SIGAR 14-31 Inspection Report

SALANG HOSPITAL: LACK OF WATER AND POWER SEVERELY LIMITS HOSPITAL SERVICES, AND MAJOR CONSTRUCTION DEFICIENCIES RAISE SAFETY CONCERNS

**JANUARY
2014**

Figure 1 - Location of Earthquakes in Afghanistan from 1964 through 2004

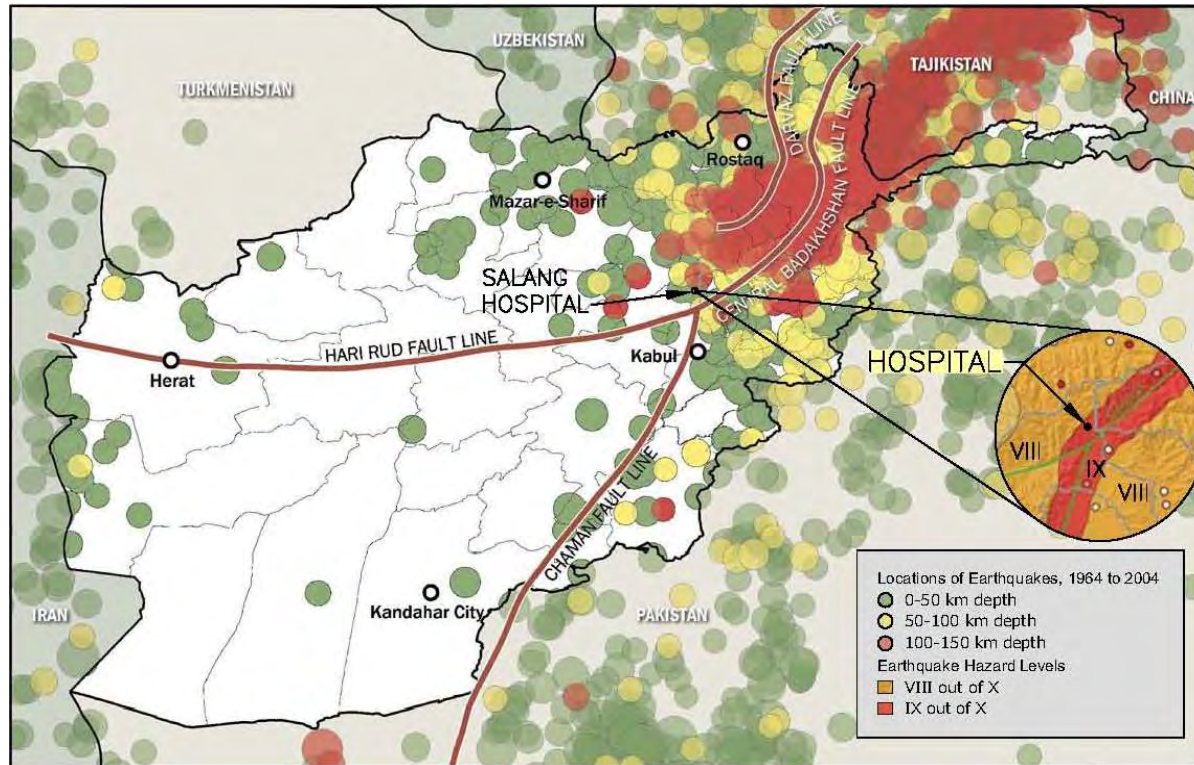
1997 to 2007.⁴ Substandard construction that does not meet industry earthquake standards⁵ exposes the structures involved to increased earthquake vulnerability. Figure 1 shows the proximity of Salang hospital in relationship to the intersection of the Chaman, Hari Rud, and Central Badakhshan fault lines and the location of earthquakes that have occurred in Afghanistan from 1964 through 2004.

According to U.S. Geological Survey data, Salang hospital is located in the second highest seismic intensity zone in Afghanistan. The Chaman and Badakhshan fault lines represent the centerline of a 15 to 25 kilometer wide swath of potential destruction during a seismic event. The U.S. Geological Survey characterizes the seismic activity and potential damage for this zone as Level IX out of X. Level IX activity is described as: “Violent shaking with people forcibly thrown to the ground, monuments and columns fall, and most unreinforced masonry buildings will suffer heavy to very heavy structural damage.”

APPENDIX II - COMPARATIVE BUILDING FOOTPRINTS

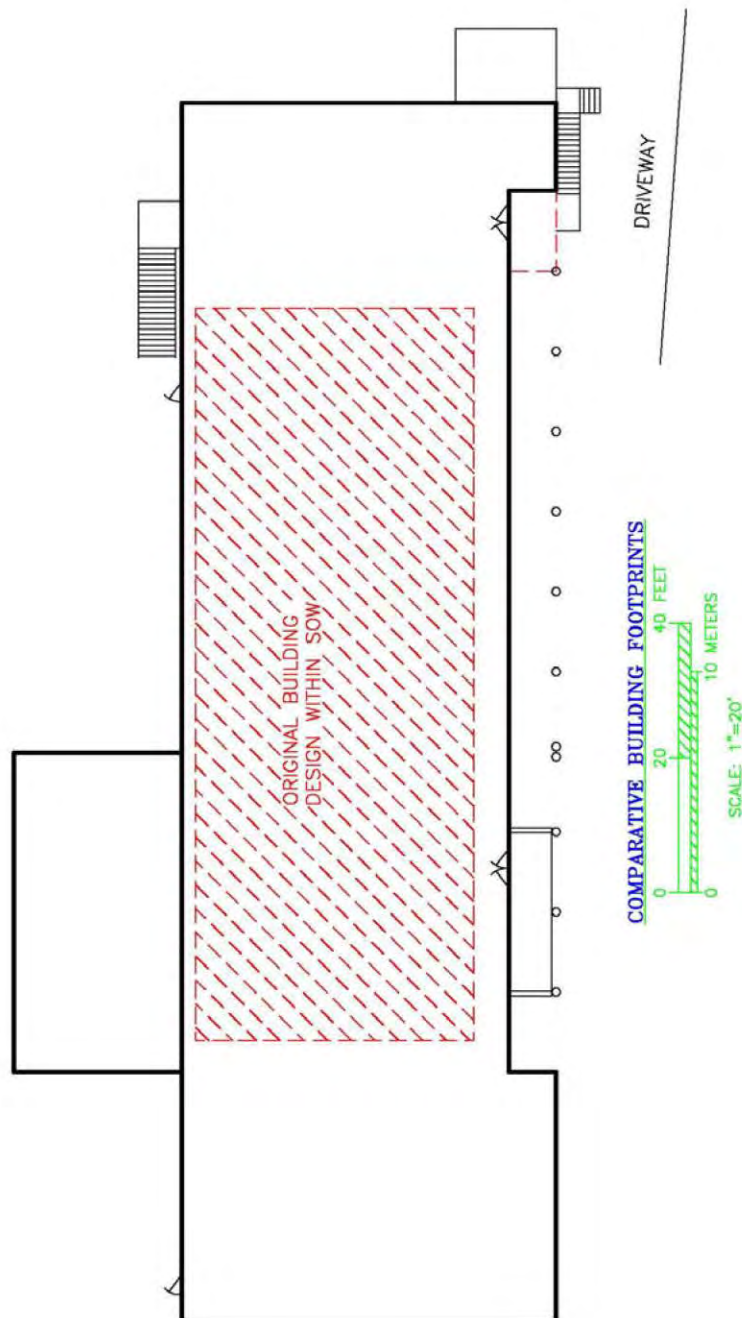
- The original design drawings called for a one-story, 15-room hospital building; a one-story four-stall toilet facility; and a guard shack. However, we found that a two-story building had been built. It was an 18,300-square-foot structure, more than three times larger than the 5,300-square-foot building called for in the original design plans. We could not find any documentation showing that the Bagram Regional Contracting Center contracting officer had modified the contract to approve the two-story building, as was required under the contract.³ According to a Provincial Reconstruction Team record of a meeting with an Afghan Ministry of Public Health official, the Department of State member of the team stated that the Ministry and the provincial government approved the alternate design; however, no documentation exists to confirm that these officials approved the design. The State Department representative also noted that the alternate design was necessary because the hospital's irregularly shaped lot would not accommodate the design called for in the contract documents. However, it is unclear to us why the lot could not accommodate the hospital as originally designed, but could accommodate a facility that had a larger footprint than was called for under the contract. See Appendix II for a comparison of the originally-designed building's footprint and that of the building that was actually constructed.

Note: The outer black lines show the 9,150 square foot footprint of the 18,300 square foot two-story hospital building actually constructed by the contractor. The shaded red box within the black lines shows the relative size of the 5,300 square foot footprint that the Salang hospital would have occupied had it been constructed in accordance with the designs provided for in the contract. It remains a question as to why the lot was inappropriate for the 5,300 square foot building, but suitable for the 18,300 square foot building.
